Request for Class II Permissive Change(C2PC)

FCC ID: VG8XM0P04YY

Date: 2024-12-30

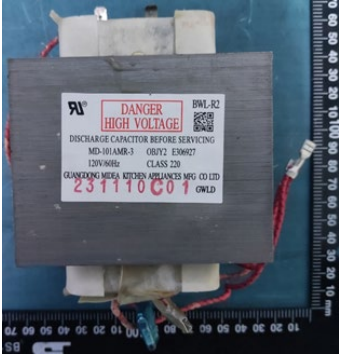
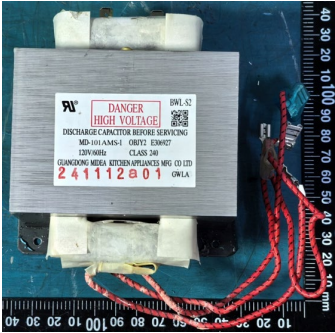
No.:	Original	New	Difference(s)
1			Difference for High-voltage transformer as below: Difference only for model number, the new high-voltage transformer is MD-101AMS-1, the original is MD-101AMR-3. The insulation level has been increased, S: 240deg, R: 220deg.
